February 19, 2025

**ADDENDUM NO. 5
TO THE
CONTRACT DOCUMENTS
FOR
CUMBERLAND COUNTY TRANSFER STATION**

Cumberland County Municipal Solid Waste Transfer Station Fayetteville, NC

CONCRETE WASHOUT AREA

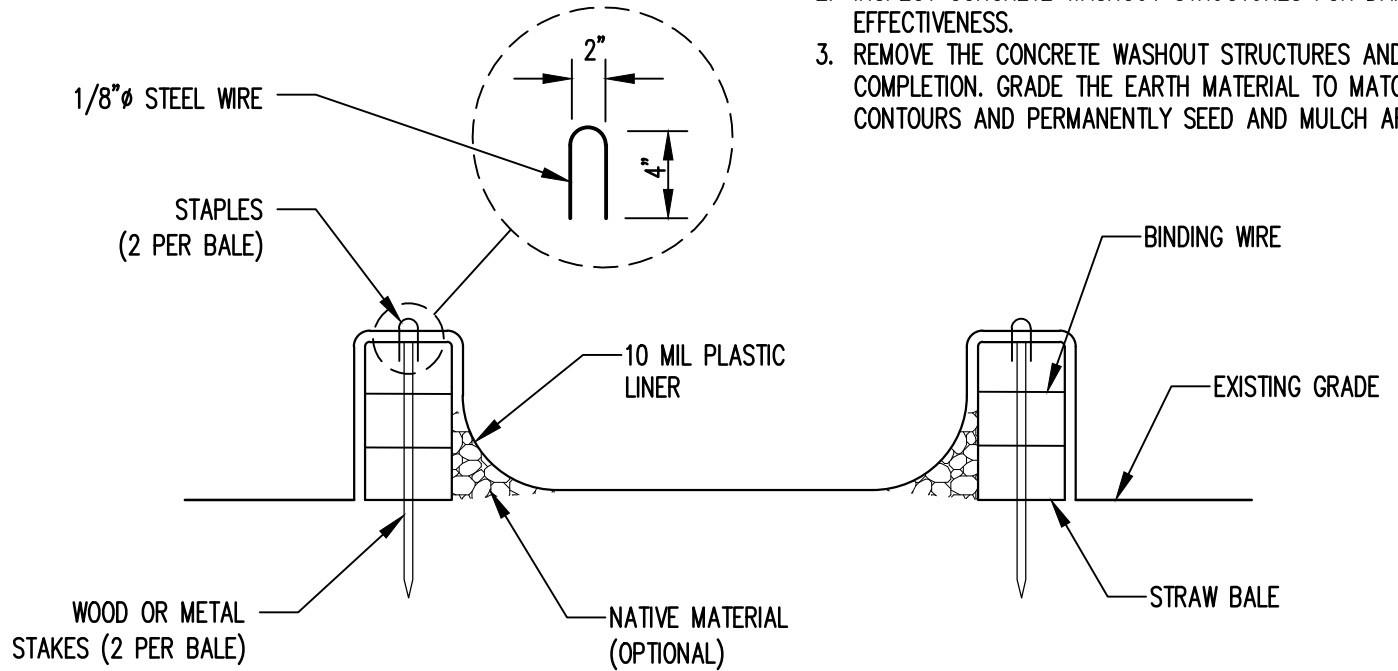
- AD5-7. *Please confirm location / details for the required concrete washout pit onsite.*

The County, Engineer and Contractor will coordinate a location for the concrete cleanout in the vicinity of the proposed transfer station. See attached detail.
